Portugal Street East, The Fairfax

Design Justification Statement

The following presentation has been produced to set out the developed design compared to the approved planning drawings. The drawings are all labelled with reference to Schedule 1.0 which sets out the design revisions.

Block 1, Level 29th Floor, Amenity Glazing - Proposed Design

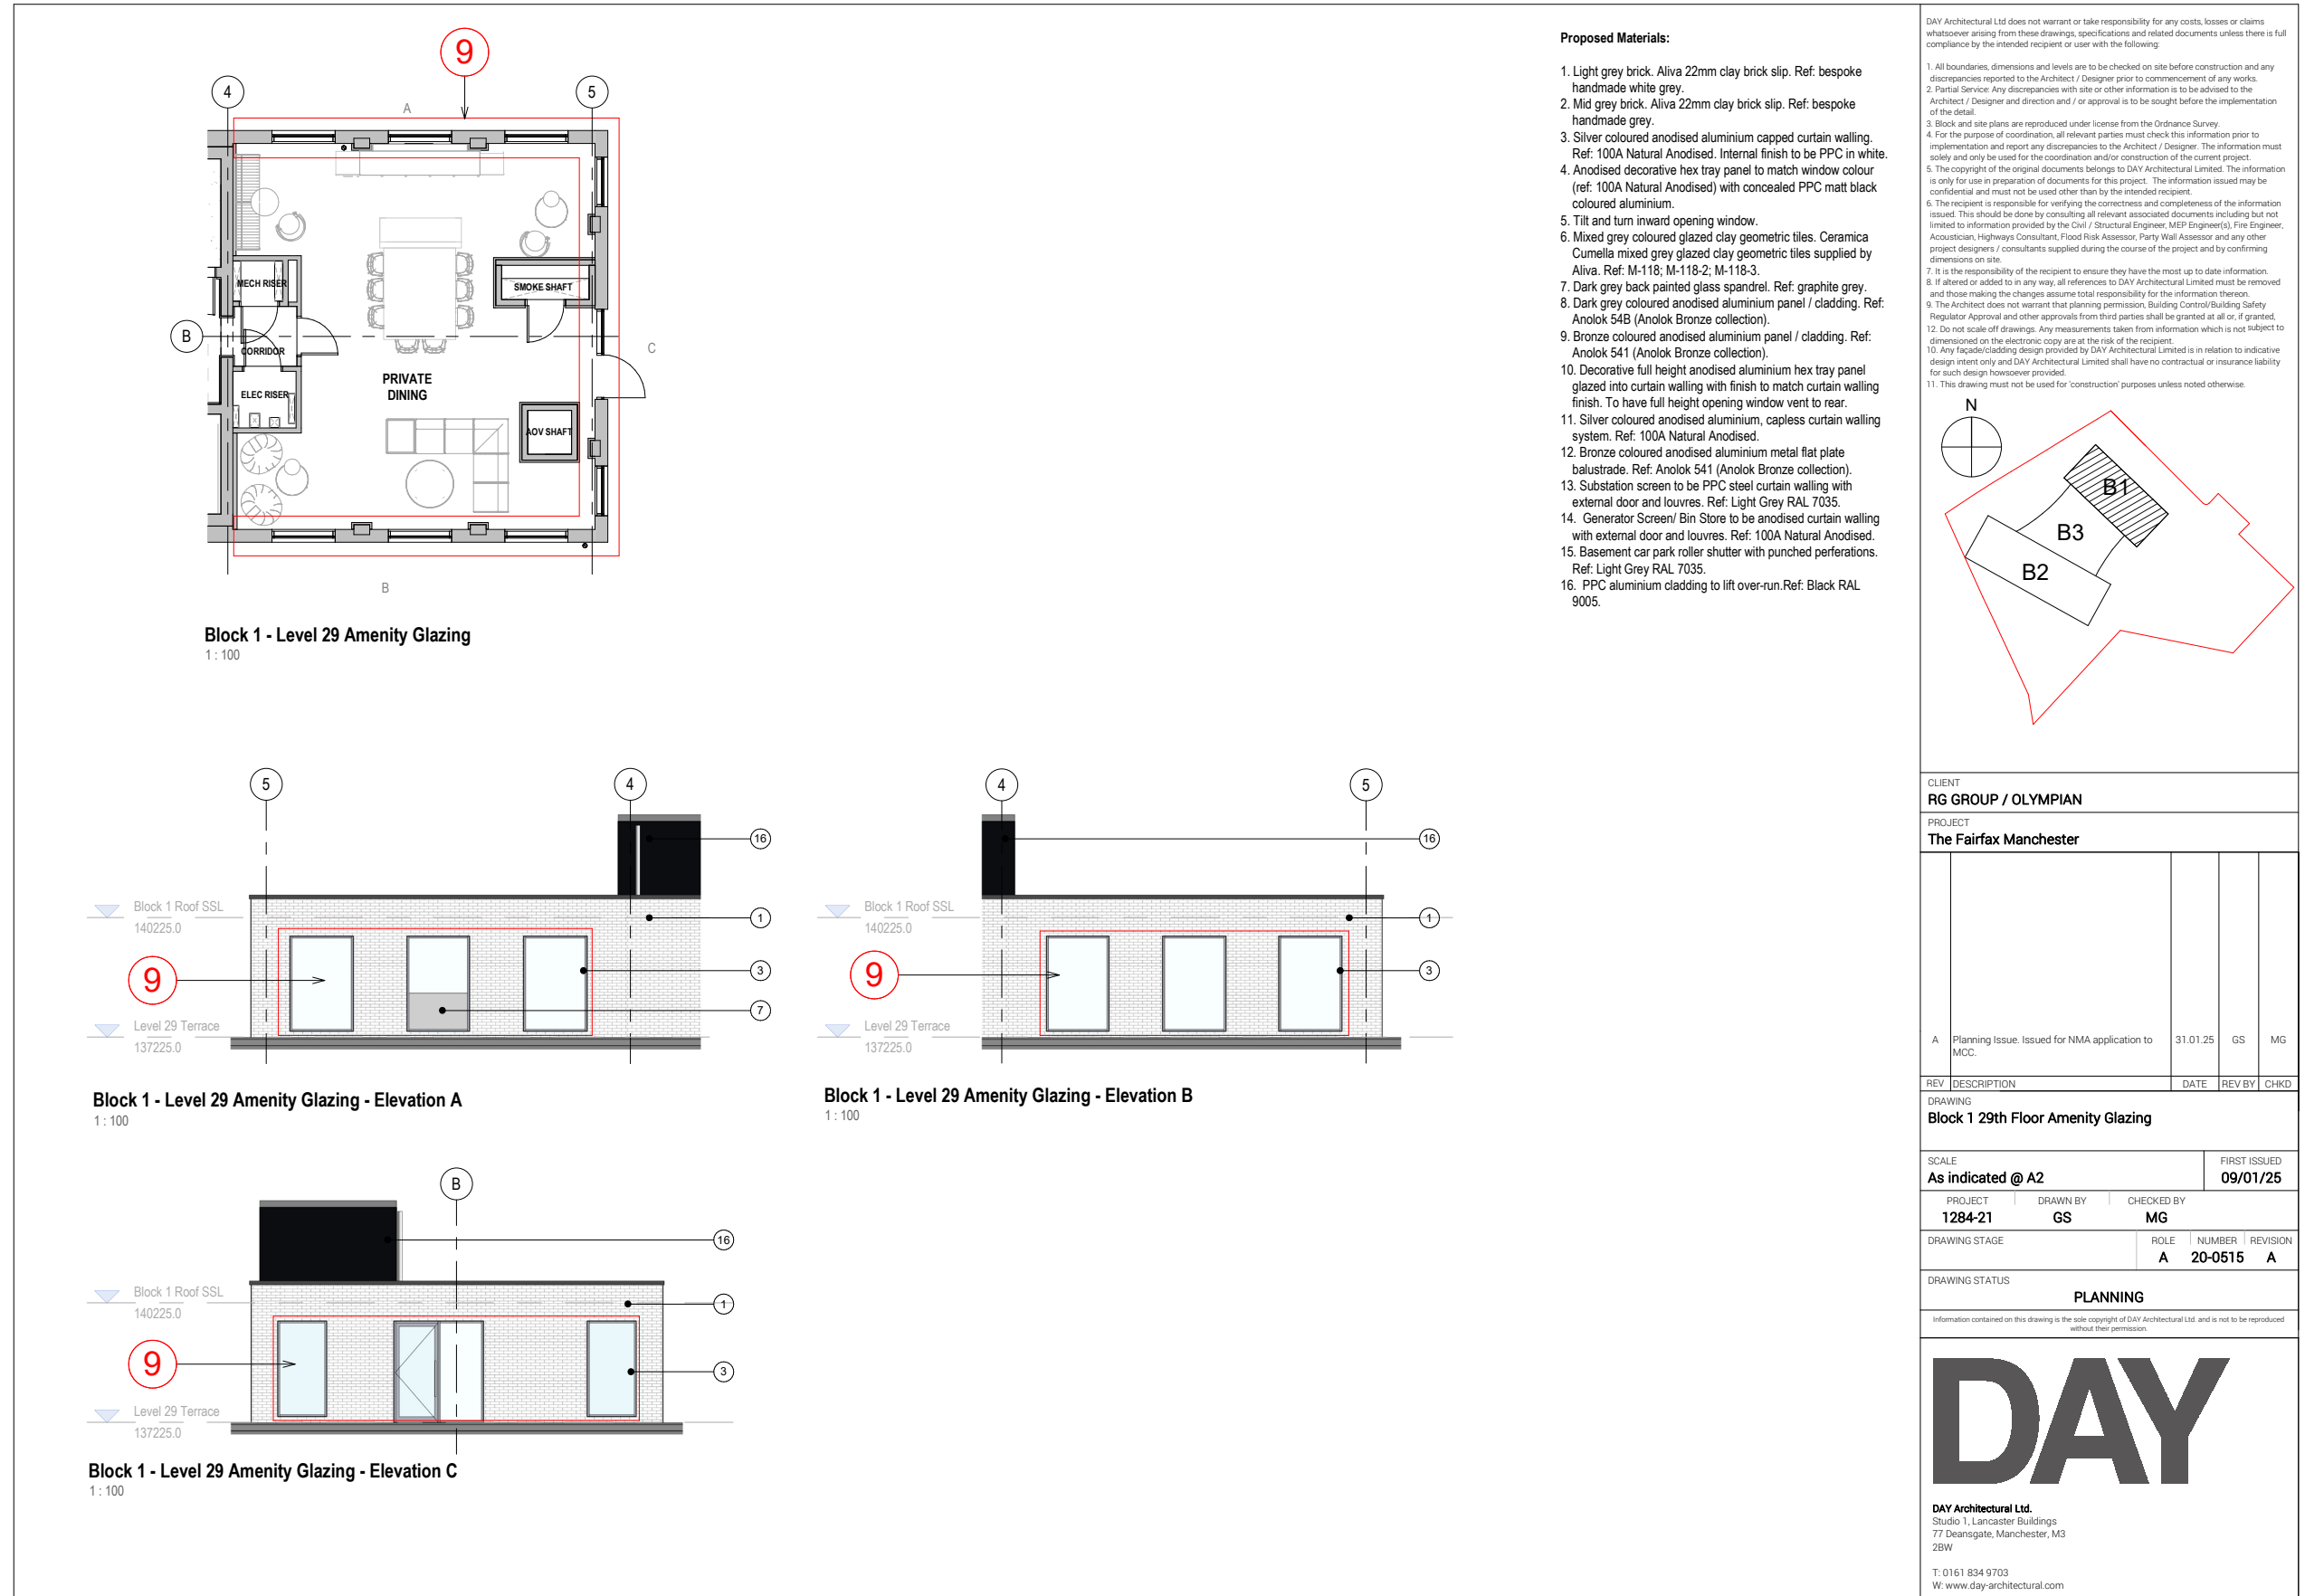
9	Block 01 Level 29 amenity space	Size of roof terrace increased to provide additional external amenity and design of external elevations finalised	The roof terrace has been increased in size by 150m2 to maximise the external amenity provision and provide panoramic access, whilst ensuring a sufficient secure external maintenance area is retained for maintenance access and operation purposes	20-0103 REV E 20-0107 REV F 20-0108 REV F	20-0103 REV F 20-0107 REV G 20-0108 REV G 20-0515 REV A
10	Block 01 and 02 emergency egress escape doors and screens	Amendments to external elevations (approved under NMA application reference 138154/NMC/2023)	To amend the approved elevations to reflect the changes agreed under NMA application reference 138154/NMC/2023	20-0203 REV E 20-0205 REV E	20-0203 REV F 20-0205 REV F
11	Block 01 additional door	External door added in place of fixed glazed unit. Size of opening remains as per approved design	Internal arrangement has changed to provide a residents only use dog grooming facility. External door added to provide external access for residents to the residents to avoid having to access via the main entrance and circulation route	20-0203 REV E	20-0203 REV F
